# Rockwell service letter No. SL-AG-73

Service Letter No. SL-AG-73  
July 7, 1975

### REPLACEMENT OF TAIL WHEEL SHOCK STRUT EXTENSION ASSEMBLY

**MODELS AFFECTED:** MODEL S-2R, SERIAL NO'S 2167R THRU 2173R AND 5011R THRU 5048R.

Figure 1.

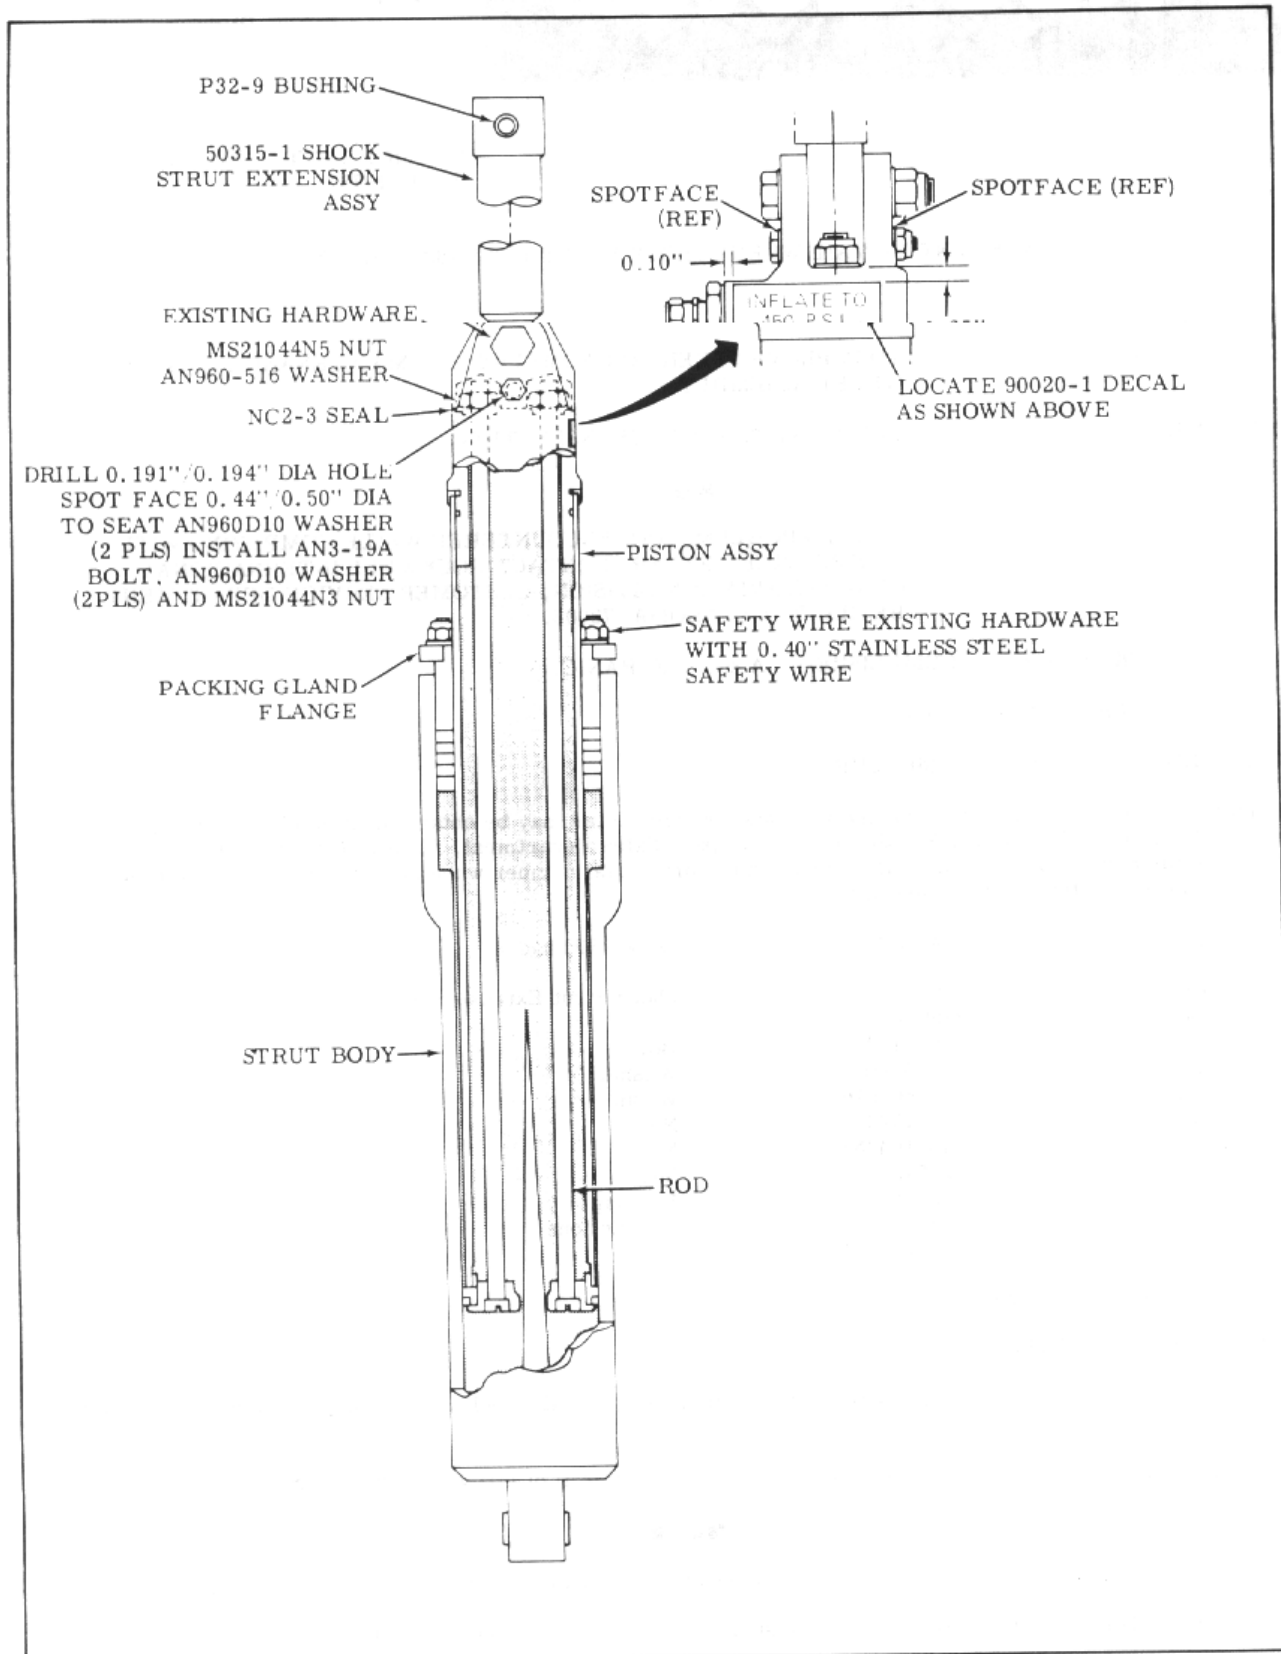
**REASON FOR PUBLICATION:** To improve steering geometry and maintenance of tail wheel assembly.

5. After shock strut assembly has been deflated, remove filler plug and drain all fluid.
6. Modify the existing shock strut assembly as follows:
  - a. Remove lockwire and four (4) nuts on the studs that hold the packing gland flange in place (see Figure 1.).

- b. Remove the piston assembly from the strut body.
  - c. Remove and discard existing shock strut extension assembly and seals.
  - d. Install NC2-3 seal, AN960-516 washer and MS21044N5 nut (2 places) on existing rods see Figure 1.).

- e. Press fit P32-9 bushing in 50315-1 shock strut extension assembly (see Figure 1.).
  - f. Install 50315-1 shock strut extension assembly on existing shock strut assembly using existing hardware (see Figure 1.).

- g. Drill a 0.192 (+0.002, -0.001) inch diameter hole through shock strut cap and extension assembly (see Figure 1.).

- h. Spot face holes drilled in shock strut cap 0.47 ( $\pm$  0.03) inch diameter to seat AN960D10 washer (see Figure 1.).
- i. Install AN3-19A bolt, AN960D10 washer (2 places) and MS21044N3 nut (see Figure 1.).
- j. Reinstall piston assembly in strut body, tighten four (4) nuts just enough to prevent leakage past packing rings, and safety nuts with 0.040 inch diameter stainless steel safety wire.

- 7. With strut assembly in a vertical position and fully compressed, fill with MIL-H-5606 oil up to filler hole and install filler plug.
- 8. Inflate shock strut assembly to 450 psi air pressure and check for leaks.
- 9. Install 90020-1 decal (see Figure 1.).
- 10. Reinstall modified shock strut assembly on airplane using existing hardware.
